PowerXL

RAM05/RASP5 Firmware

Firmware Release Note

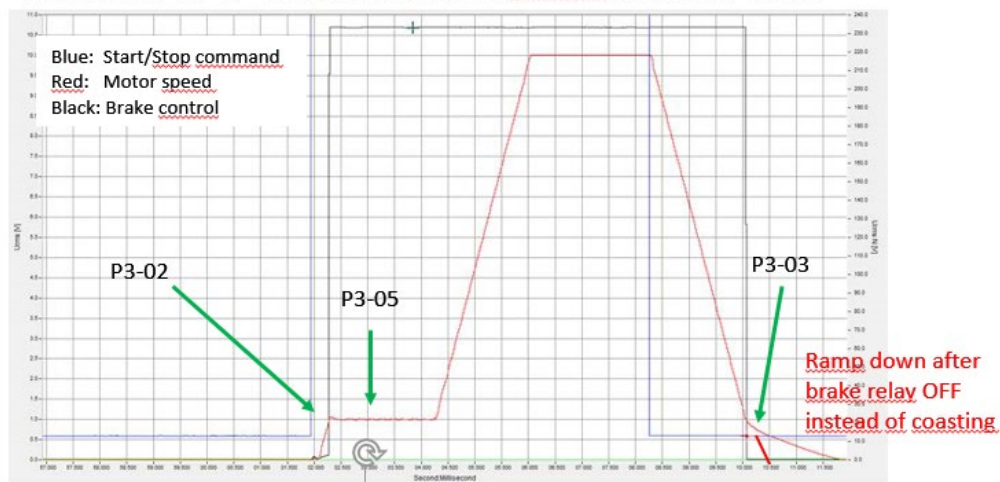
4. Default parameter value changes

New default value has been given to the following parameters

P6-02 = 100%

P6-03 = 0.025s

P6-15 = 2.5%

P6-17 = 0

P6-14 default value as shown in table below:

6. Added New Advanced Mode 2 Brake Control Option (P3-01 = 2)

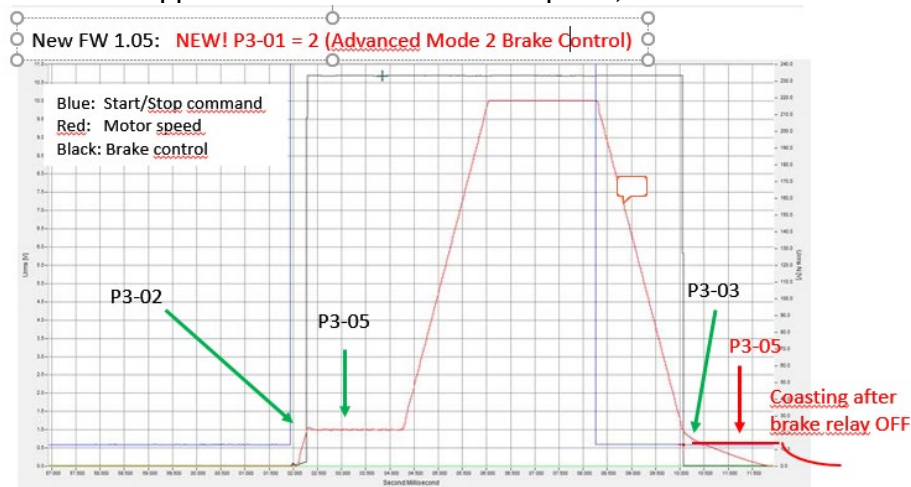
A new option has been added to P3-01 for advanced brake control (P3-01=2).

After receiving a STOP! command, drive will ramp down to Brake Apply Speed (P3-03) and remain at this speed for the time specified on P3-05 waiting for the motor brake to be applied. After this time has expired, drive will coast to stop (C2S).
